Responsible: U. Laarmann
Date: 08.12.2008

NOISES CAUSED BY THE FLOW OF GAS FOR THE IKEF248-5 MODEL

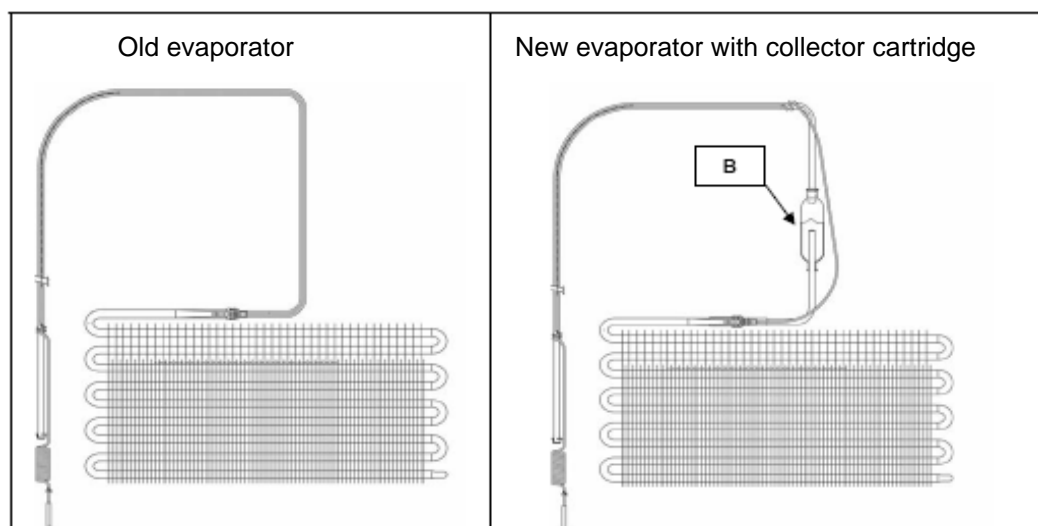
Models IKEF 248-5 are showing loud noise when cooling gas flows. This noise is caused when gas flows through the capillary.

In order to rectify the problem it was necessary to replace the evaporator and to adjust the quantity of cooling gas filled in.

If the evaporator is to be replaced, the new evaporator with a collector cartridge B (replacement evaporator, spare-part no. 433953) will need to be ordered. The collector cartridge is to be filled with 48 g of refrigerant gas instead of 45 g (change info on the datum plate of the appliance).

A	1 evaporator	Spare-part no. 433953
B	2 adhesive noise-absorbers	Spare-part no. 433322

1. Remove the appliance from the installation niche.
2. Disconnect the appliance from the mains supply.
3. Access the evaporator.
4. Disconnect the return pipes and the capillary of the old evaporator and remove the evaporator.
5. Install the new evaporator and re-connect the tubes to the new evaporator.
6. Install the two "noise absorbers": one on the injection point on the side of the battery and the other at the point where the capillary emerges from the exchanger in the engine compartment.
7. Refill the cooling circuit, observing the new volume of gas (48 g).
8. Re-connect the appliance and push it into the installation niche.
9. Once this has been completed adjust the volume of gas indicated on the nameplate, indicating the new quantity (48 g).
